HAY CREEK VALLEY

PRELIMINARY SITE DEVELOPMENT PLAN

PROJECT:
**HAY CREEK VALLEY SUBDIVISION
PRELIMINARY SITE DEVELOPMENT
PLAN
EL PASO COUNTY, CO
01/20/2023**

V1_Preliminary Plan Drawings.pdf Markup Summary 2-28-2023

TS01

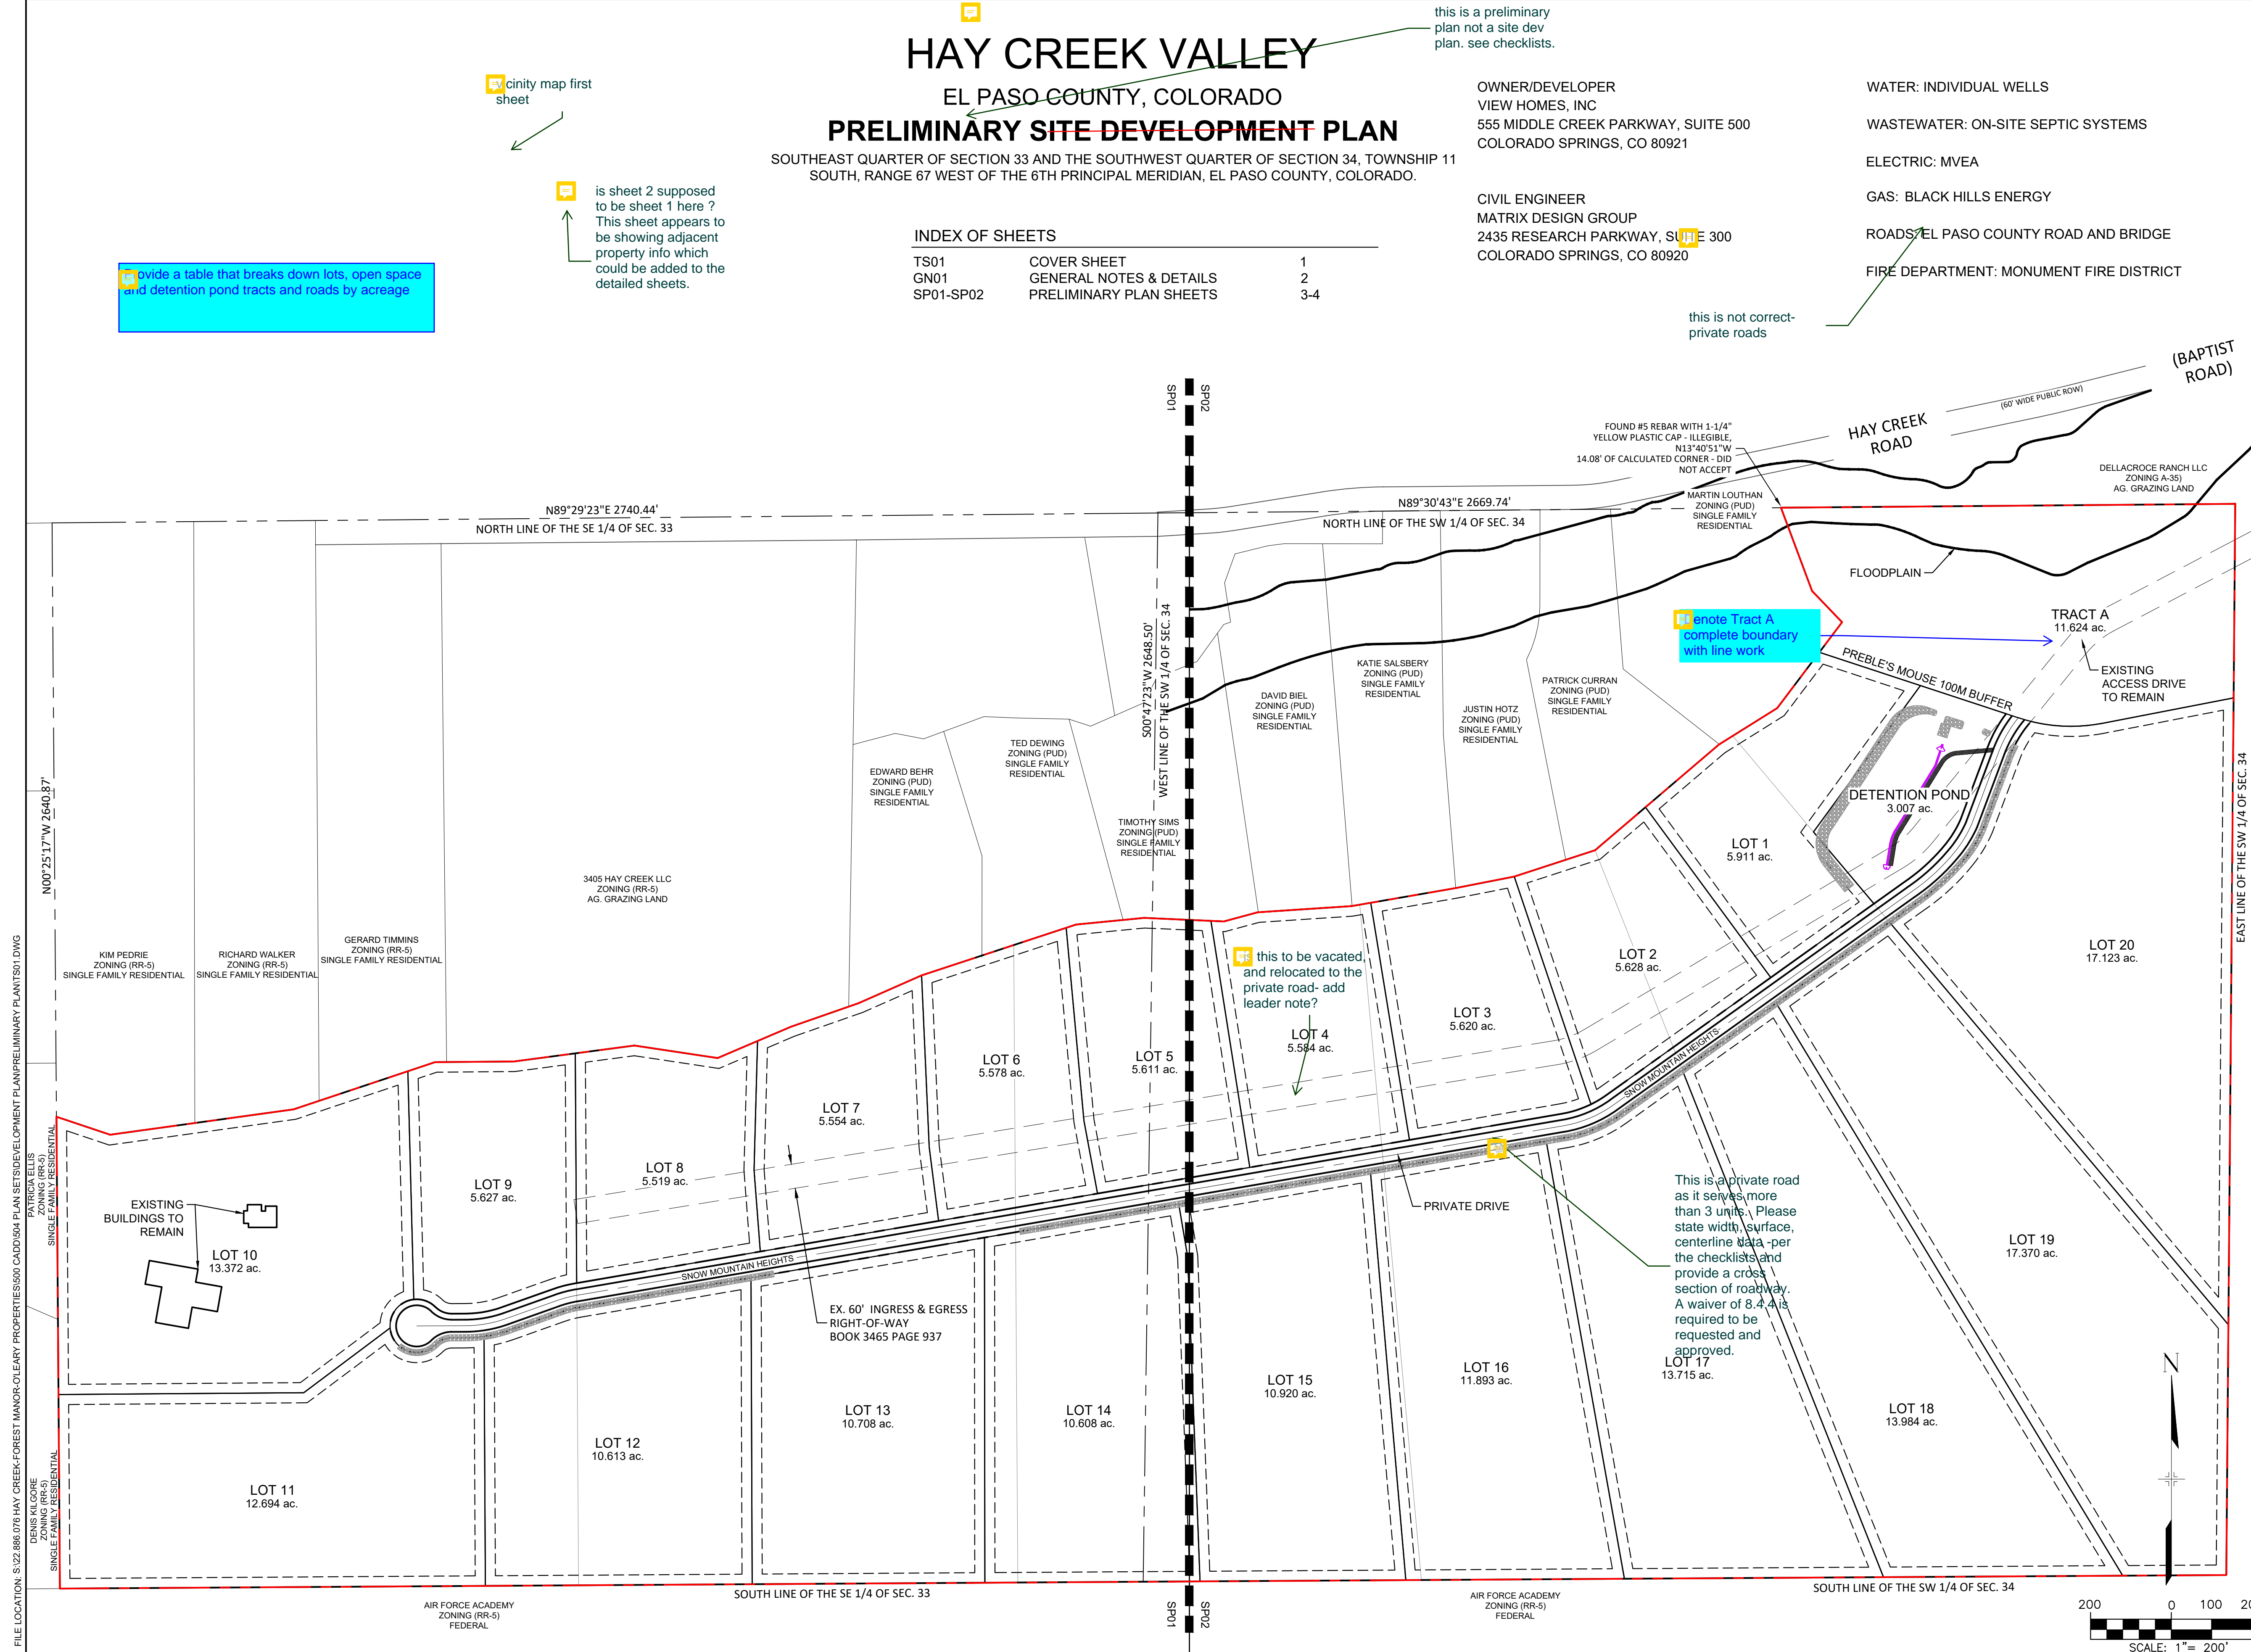
this is a preliminary plan not a site dev plan. see checklists.

Divide a table that breaks down lots, open space and detention pond tracts and roads by acreage

city map first sheet

is sheet 2 supposed to be sheet 1 here? This sheet appears to be showing adjacent property info which could be added to the detailed sheets.

this is not correct- private roads

Note Tract A complete boundary with line work

this to be vacated and relocated to the private road- add leader note?

This is a private road as it serves more than 3 units. Please state width, surface, centerline data per the checklists and provide a cross section of roadway. A waiver of 8.4 is required to be requested and approved.

SP01
SHEET 03 OF 04

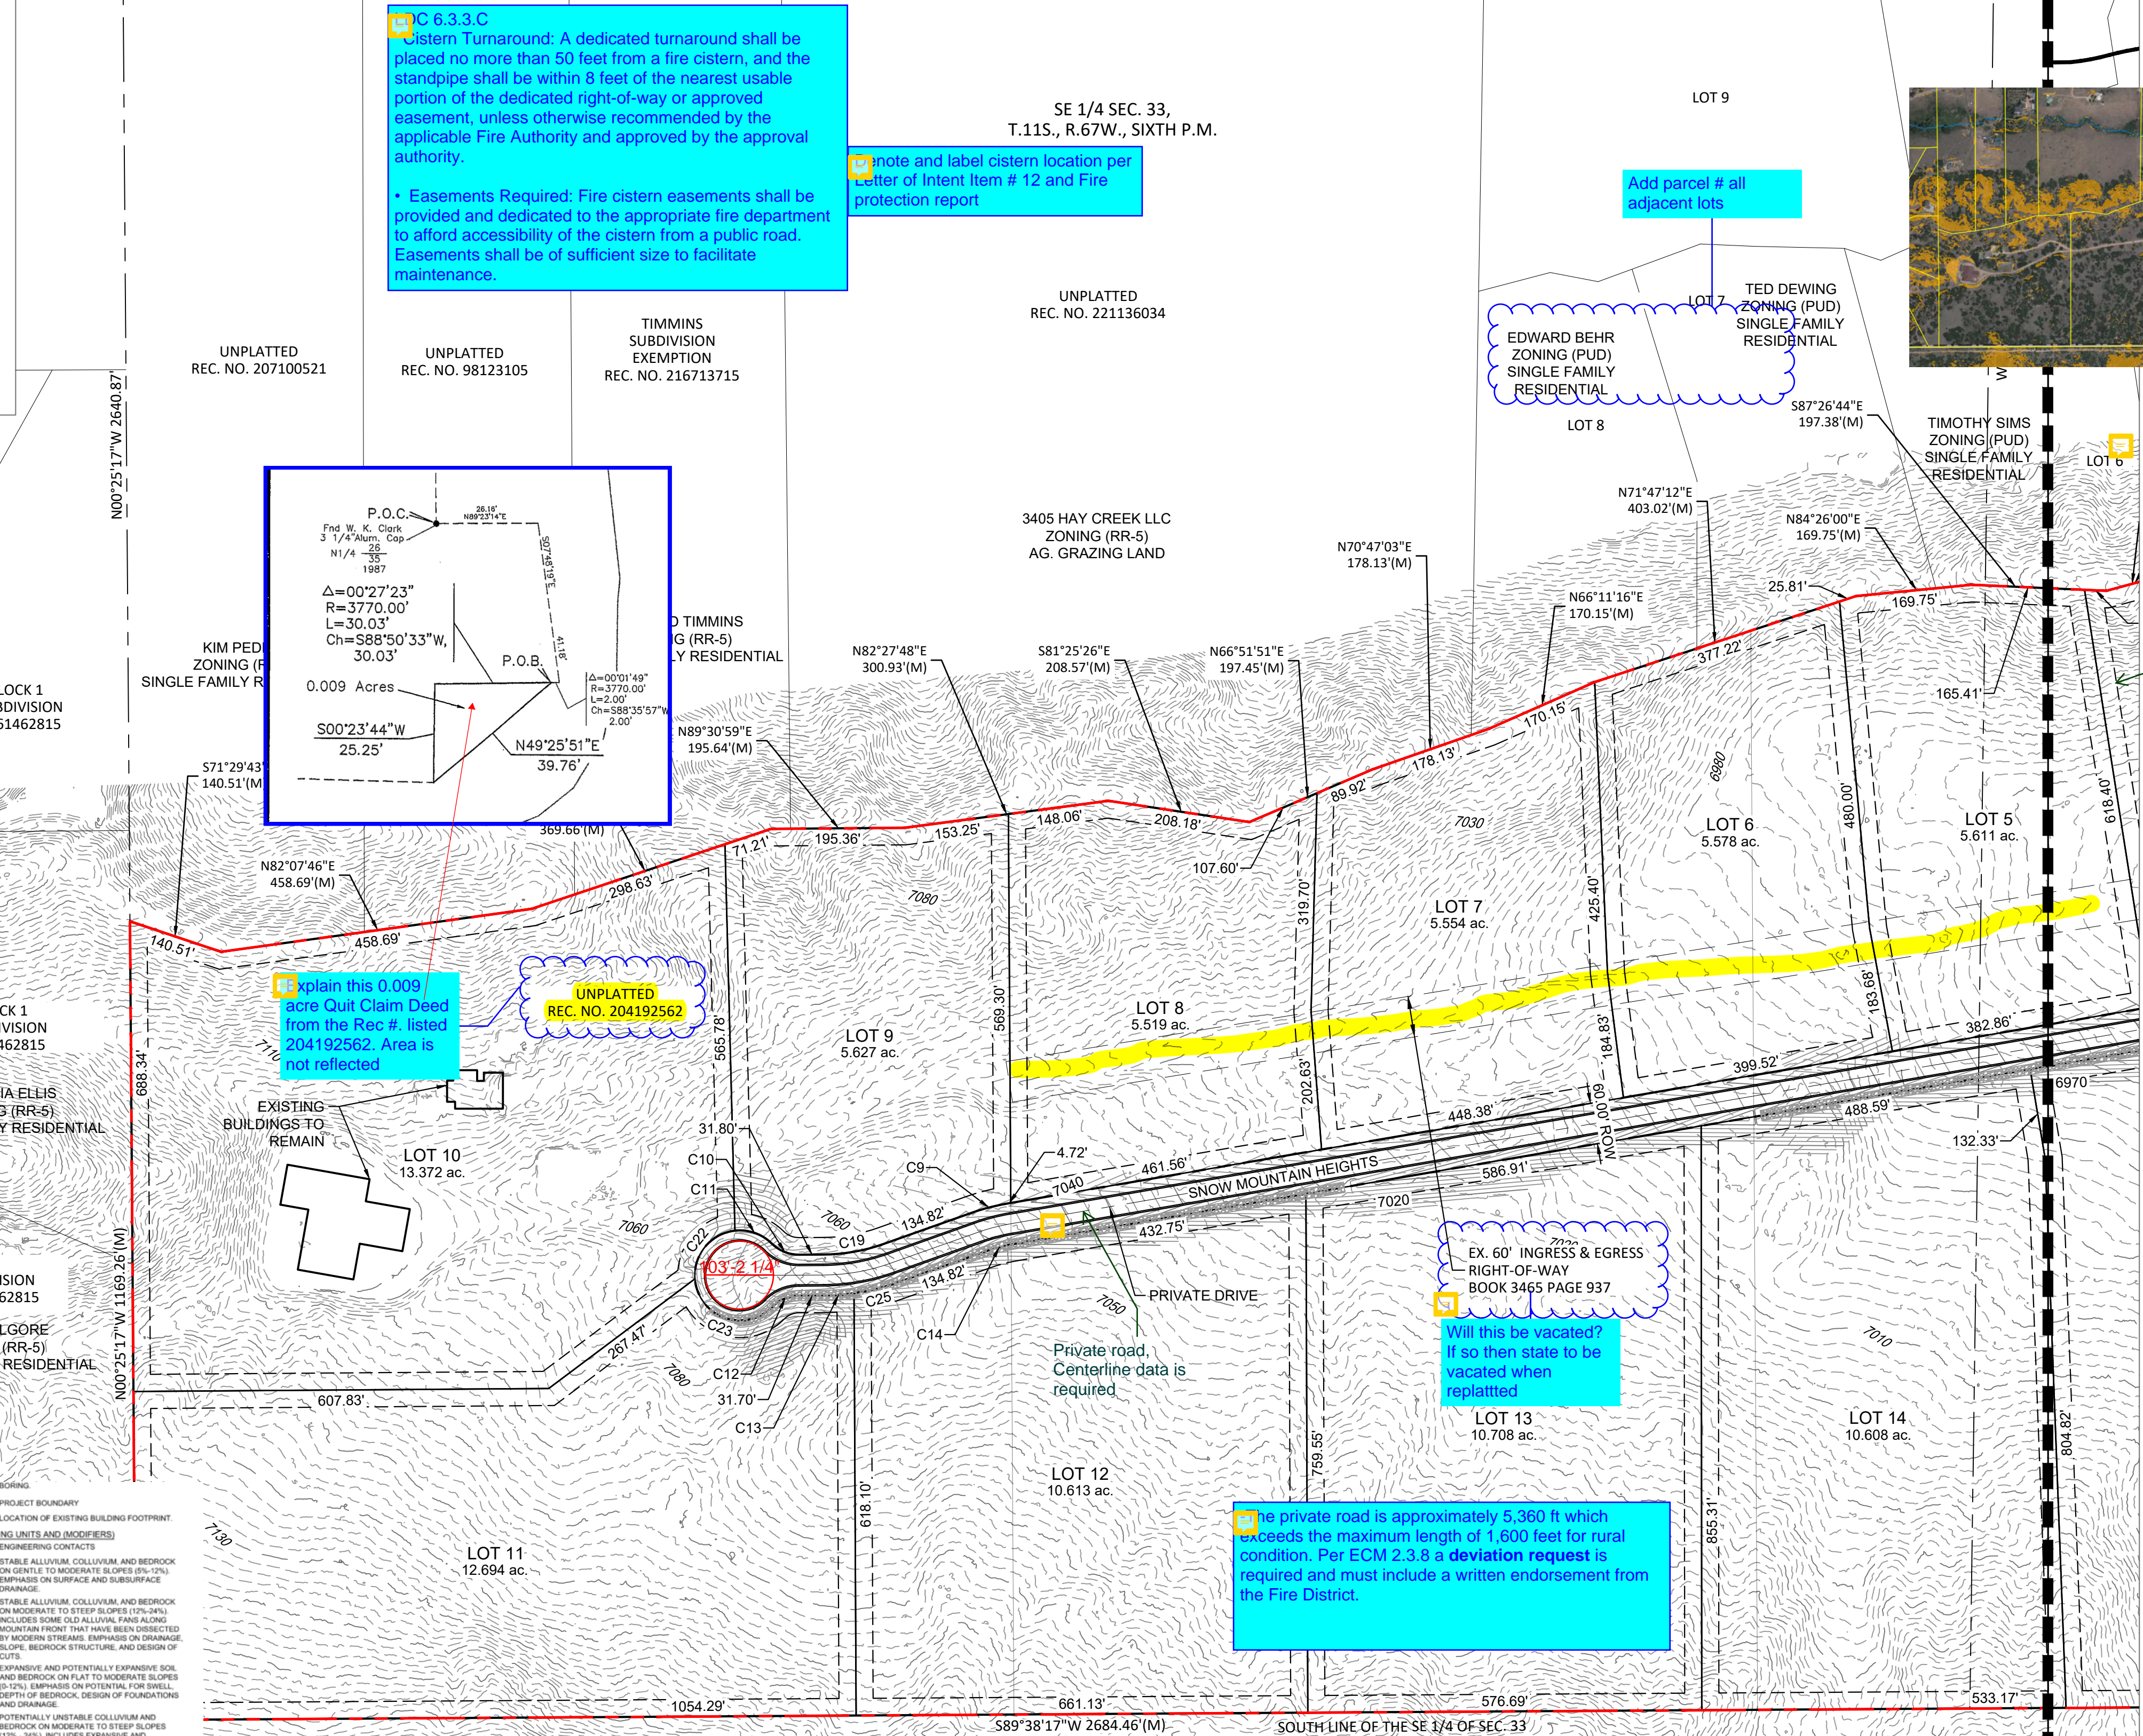
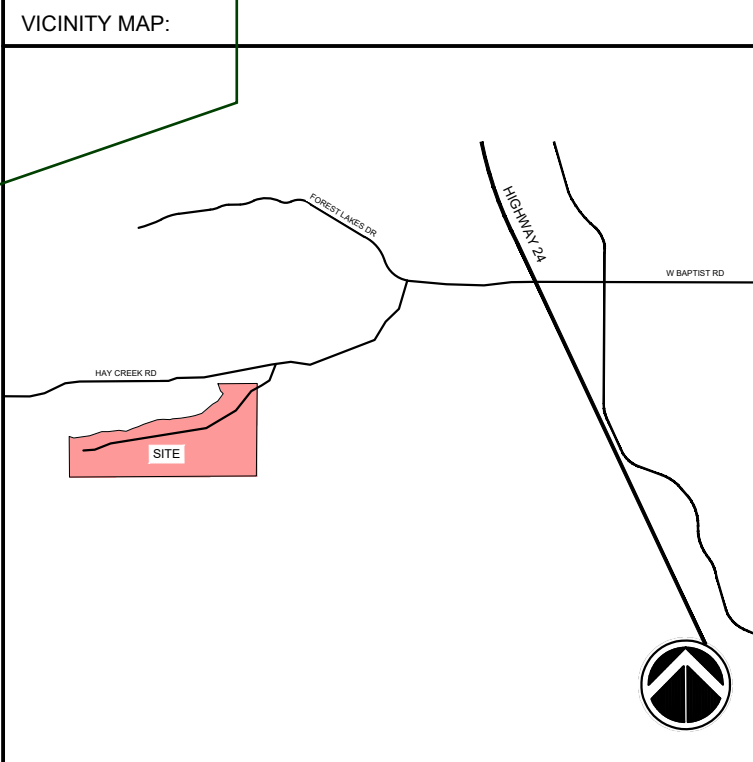
Note and label cistern location per Letter of Intent Item # 12 and Fire protection report

Add parcel # all adjacent lots

label the no build areas please; anything w slope 30% higher; rockfall; unstable slopes etc

these (slopes and floodplain areas) should be included as depicted no build areas on plan and reflected in the notes specific to the lots as should the bedrock and drain constraints

U.S.G.S. quadr maps shall not be accepted as evidence for topographic contours.

depict Cistern tract, and add note size, location, and M of Cistern
 if there no rock outcroppings on the site to be protected?

SP02

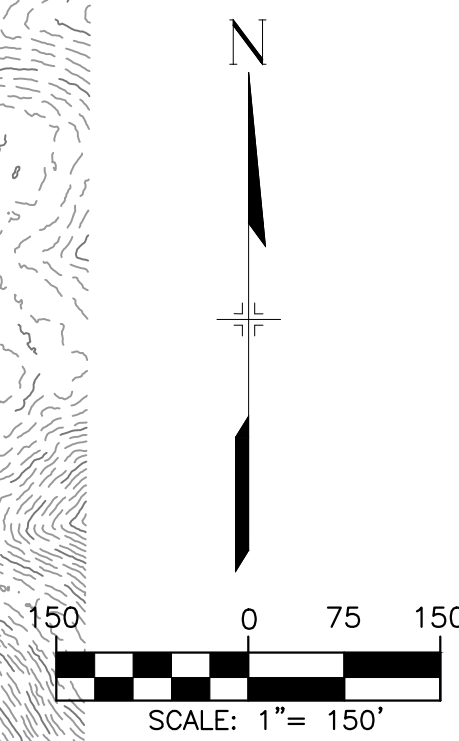
Per LDC 8.4.2.B.1 Approved Base Flood Elevation (BFE) and 100yr boundary shall be shown on the Plat. Please show FEMA approved BFE with new boundary and reference case #

Adjust view to include intersection

Label this access easement or ROW by Book or Rec #

Show private road continuation all the way to Hay Creek Rd to include intersection
 Provide curve and intersection details
 Intersection will require 90 degree realignment
 This road section will need to be paved
 Intersection alignment must meet criteria (ECM 2.3.7.C.2). Should be at 90 +/- 10 degrees.
 Traffic Impact Study to verify sight distance at the intersection especially to the east.

Denote Tract A boundary to include detention pond and add required easement around pond

Label this easement and add note if to be vacated

Note all driveway entrances from the Private road must meet grade limits per LDC 6.3.3.C.3 Grading plan and Road CDs must ensure lots do not have driveway slopes exceeding 10% and driveway entrances do not exceed 4% for the first 20ft. Transition grades are 6% maximum for a distance of 50 feet minimum.

Are you incorporating the recommendation in the Wildland fire report in regard to home placement, (highlighted in yellow in report) road turn arounds -600-feet? slope avoidance? I didnt see that in the notes or reflected in no build areas or road plan?

Add parcel # for all adjacent lots
